E-Rate 25 (FY2022) Internal Connections Q & A (Form 470 #220011387)

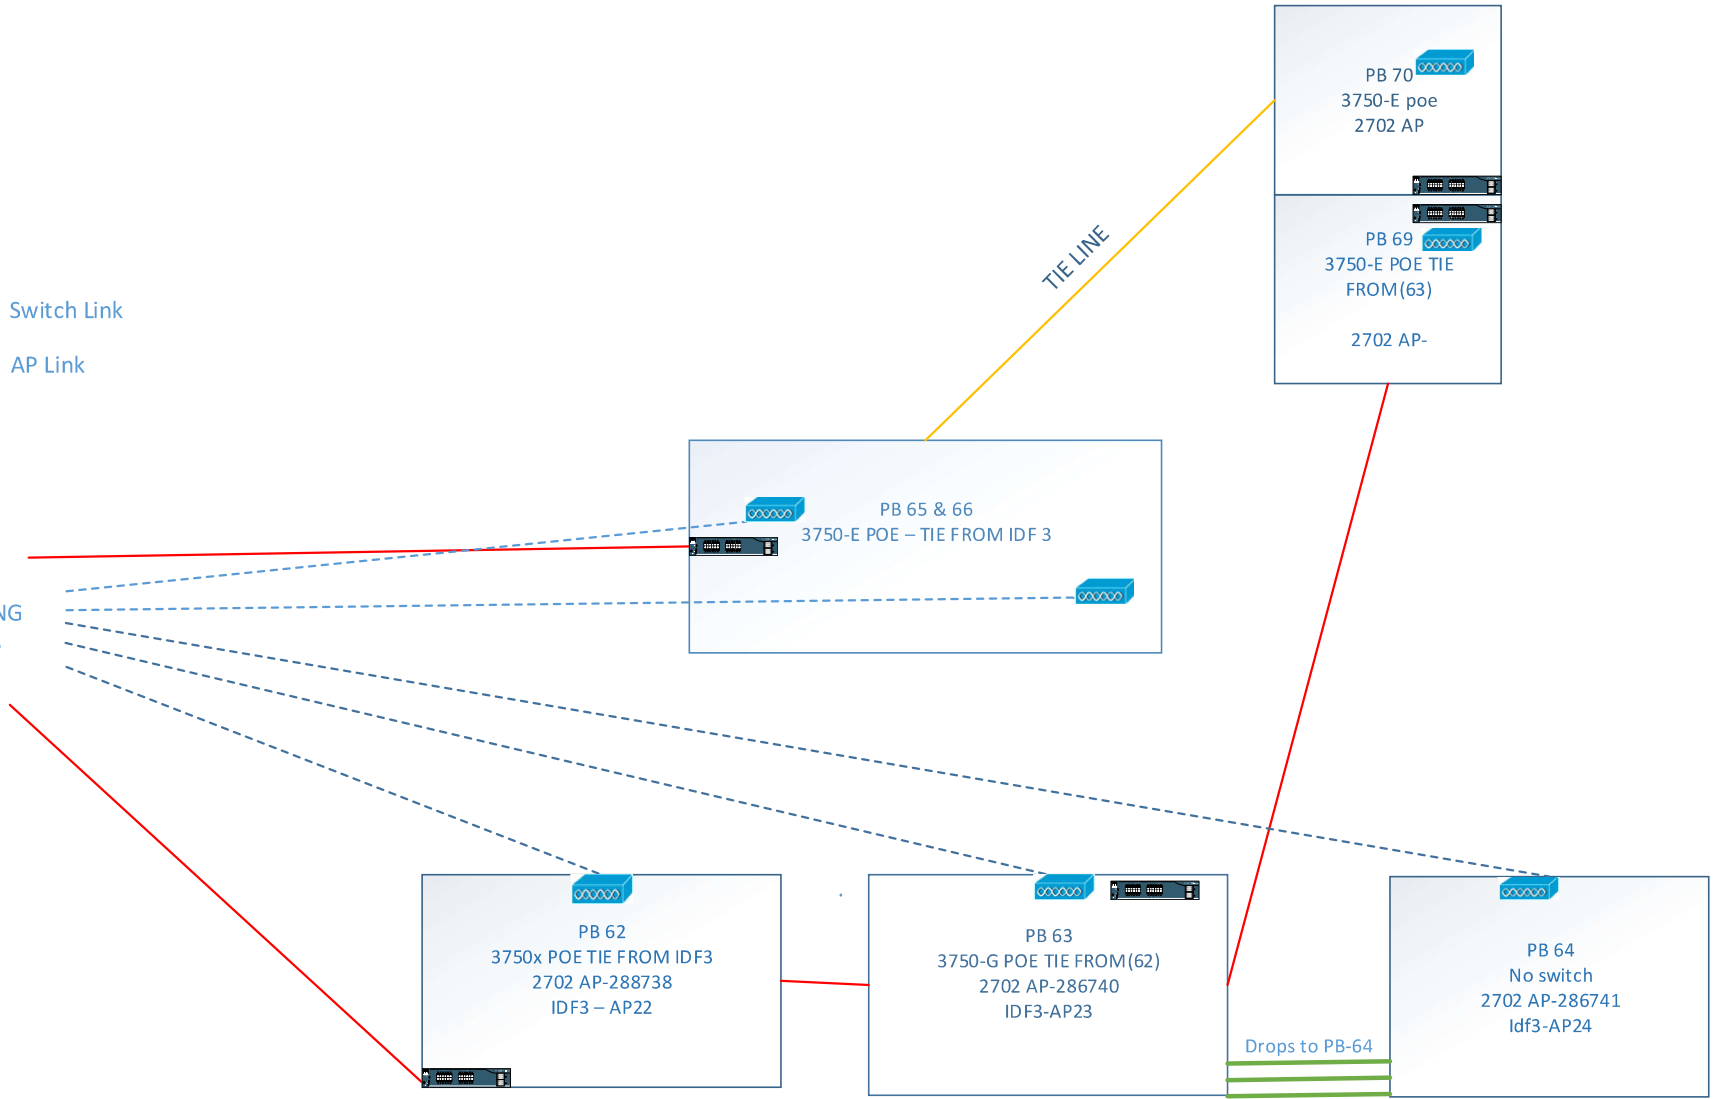
Question-20: Are Barrientes Middle School Fiber runs 10GB rated?

Answer-20: Existing Barrientes Middle School Fiber is OM-2.

MAIN BUILDING IDF-3

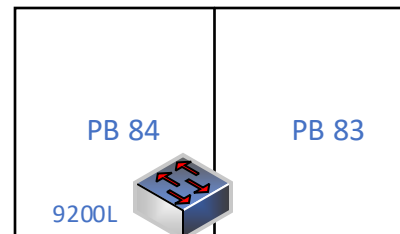
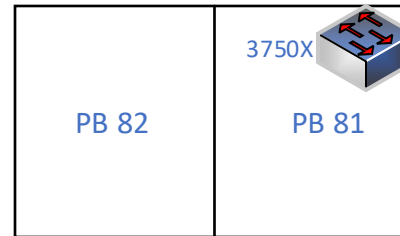
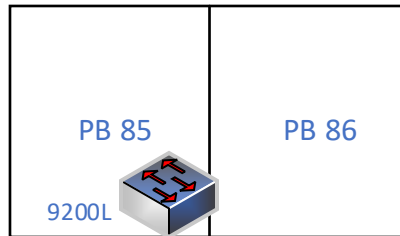
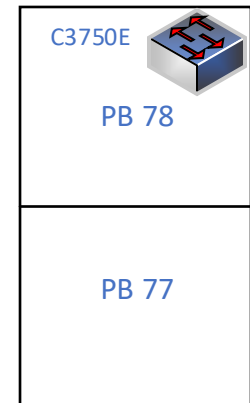
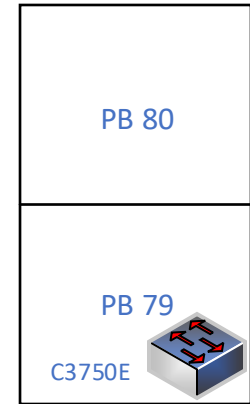
Question-16: Will you provide pictures of each portable building to know layout of switch?

Answer-16: We will provide a visual IDF map layout of portables, by campus.
